## **Title: Interpretation of article 15 in NC DCC – Belgian DSOs**

### **Topic: correct understanding of article 15.1 (f) and 15.2 of the NC DCC**

*Date: 2016-09-09*

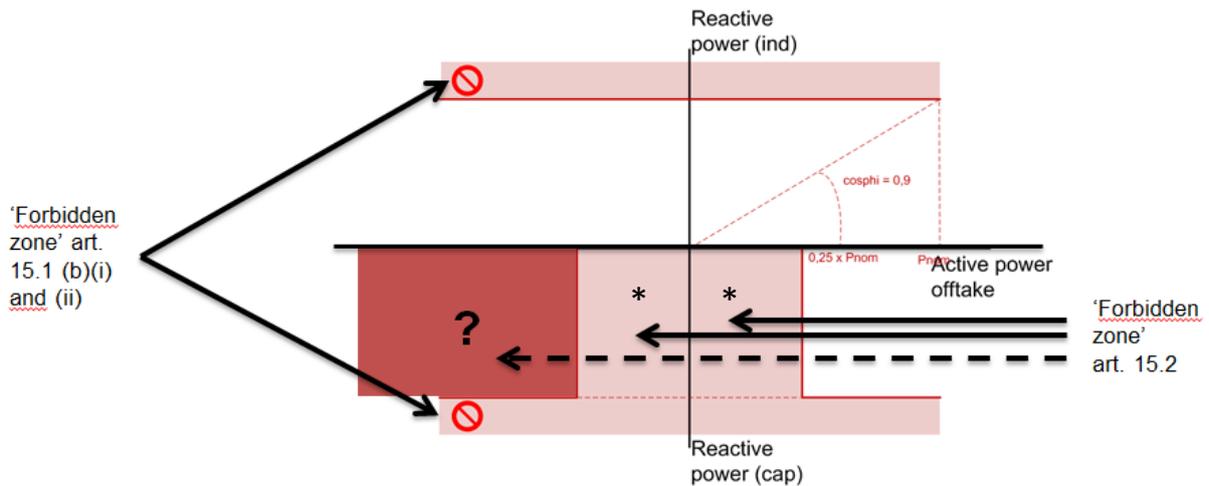
The connection point between a distribution grid and a transmission grid (typically a transformer station) will most probably always be a 'mixed' connection point. Power generating modules and demand facilities will be connected at the same connection point, not necessarily directly, but at least indirectly via the distribution lines connected to that connection point.

So, one could argue that article 15.1.f would be applicable to (almost) all connection points between the distribution and the transmission grid...

... but since the exact phrasing is not mentioned in plural but in singular (power generating module and demand facility) we conclude that the paragraph will not be applicable to the DSOs' connections points to the transmission grid.

**Can this latter statement be confirmed ?**
